Subject: UniStar Nuclear Energy, NRC Docket No. 52-016  
Response to Request for Additional Information for the  
Calvert Cliffs Nuclear Power Plant, Unit 3,  
RAI 229, Question 02.05.04-20, Stability of Subsurface Materials and  
Foundations

**Response to NRC Request for Additional Information  
RAI 229, Question 02.05.04-20,  
Stability of Subsurface Materials and Foundations,  
Calvert Cliffs Nuclear Power Plant, Unit 3**

**Question 02.05.04-20**

Figure 1. Modeled water pressures in Plaxis (negative sign indicates compression).

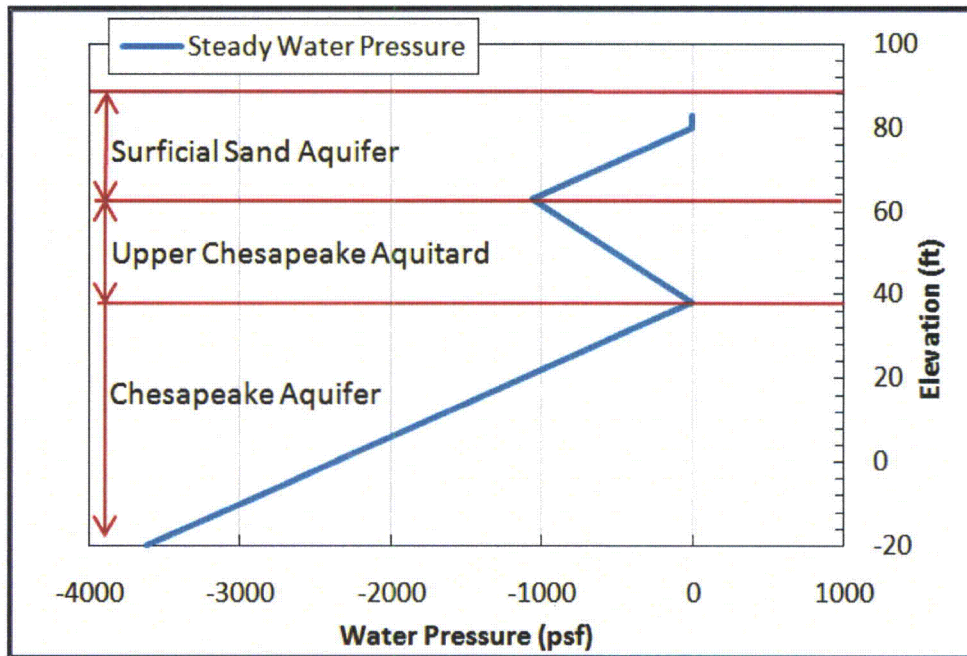
In order for staff to conduct confirmatory analyses, please provide bearing capacity and settlement calculation documents, such as: CCNPP unit 3 Power Block Area Settlement (09-4179.01-F22), Bearing Capacity of Safety Related Buildings at CCNPP Unit 3 (09-4179.01-F25) and other documents, as well as computer files, identified during the March 16-17, 2010 site audit as needed for confirmatory analyses.

- 1.1.9.2 Initial Configuration – Initial Ground Surface Input: The final model geometry of the stage is in accordance with Figure 6 of Calculation F22. The groundwater setting for this stage is in accordance with the following description. Existing groundwater elevations and water pressure profile are summarized in Section 3–1 on pp 7 of Calculation F22. Given the water pressure options available in Plaxis and the groundwater configuration reported for the site, the water pressure distribution shown in Figure 1 (below) is modeled in Plaxis.

Two distinct zones are identified: groundwater table at El. 80 ft (zones II and III in Fig. 6 of Calculation F22) and groundwater table at El. 60 ft (zone I in Figure 6 of Calculation F22, where the ground surface is also at El. 60 ft). Initial water pressures in these two zones are modeled in Plaxis as follows:

- El. 80 ft Workplane (only zones II and III): Zero at El 80 ft, and linearly increases with depth at 62.4 lb/ft<sup>2</sup>/ft
- El. 63 ft Workplane (only zones II and III): Interpolated according to the adjacent clusters in the vertical direction
- El. 60 ft Workplane: Interpolated according to the adjacent clusters in the vertical direction
- El. 45 ft Workplane: Interpolated according to the adjacent clusters in the vertical direction
- El. 41 ft Workplane: Interpolated according to the adjacent clusters in the vertical direction
- El. 38 ft Workplane: Zero at El. 38 ft, and increase linearly increasing with depth at 62.4 lb/ft<sup>2</sup>/ft
